Planning Commission Minutes  
March 13, 2025

18. (SPUD-1717) Application by Sam Gresham and Lynette Adams to rezone 2207 North Gatewood Avenue from R-1 Single-Family Residential and UC Urban Conservation Overlay Districts to SPUD-1717 Simplified Planned Unit Development and UC Urban Conservation Overlay Districts. Ward 6.

**STAFF REPORT**  
**The City of Oklahoma City**  
**Planning Commission**  
**March 13, 2025**

**(SPUD-1717) Application by Sam Gresham and Lynette Adams to rezone 2207 North Gatewood Avenue from R-1 Single-Family Residential and UC Urban Conservation Overlay Districts to SPUD-1717 Simplified Planned Unit Development and UC Urban Conservation Overlay Districts. Ward 6.**

1 SITE PLAN  
SCALE: 1/8"=1'-0"

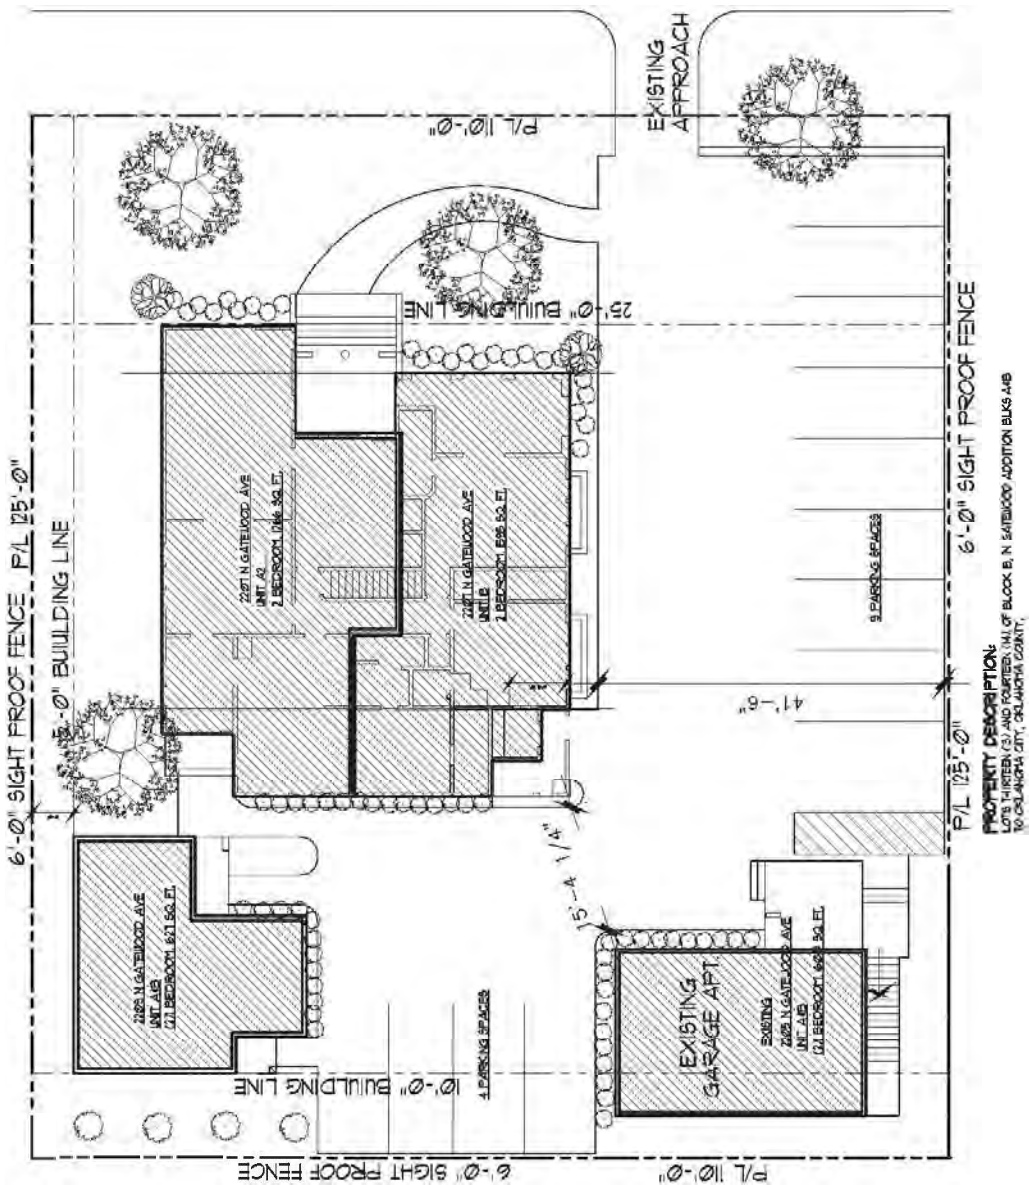
*The subject site is located along the west side of North Gatewood Avenue. The SPUD proposes utilizing North Gatewood Avenue for access. The conceptual plan for the development illustrates the site will use the existing drive along North Gatewood Avenue, near the southeast corner of the site.*

- Parking in all residential districts except R-1, R-1ZL and R-2 Districts, shall be located in the rear yard. *(The conceptual plan indicates parking located within the front and side yard setbacks.)*

- In all residential zoning districts, the maximum width of driveways is 12 feet for one-way and 20-feet for two-way drives. Circle drives are permitted, but unconnected drives in the front are not. *(The existing driveway satisfies this, but the SPUD does not address. Conceptual plans indicate 41 feet of paving for new parking areas in the front yard).*

The proposal to increase density in the Urban Medium LUTA is in conformance with UM density ranges and comprehensive plan goals to provide a mixture of residential housing types and infill development. However, the increased parking and placement in the front yard is not consistent with the Gatewood UCD. Parking areas should be located behind the front wall. Additionally, the Master Design Statement should address retention of the existing home.

1. The Master Design Statement shall specify that the existing home is being retained and may be converted to a duplex.
2. ~~Parking is not permitted within the front yard setback except on a driveway meeting the width requirements of the Gatewood UC District.~~ A maximum 4-foot-tall sight proof stone, masonry, or stucco wall shall be provided to screen any parking past the front yard setback.
3. The maximum building height shall be 2 stories and 30 feet.
4. No rooftop decks shall be allowed, and any second story balcony shall face the interior or front property line.

1. The Master Design Statement shall specify that the existing home is being retained.
2. Parking is not permitted within the front yard setback except on a driveway meeting the width requirements of the Gatewood UC District.
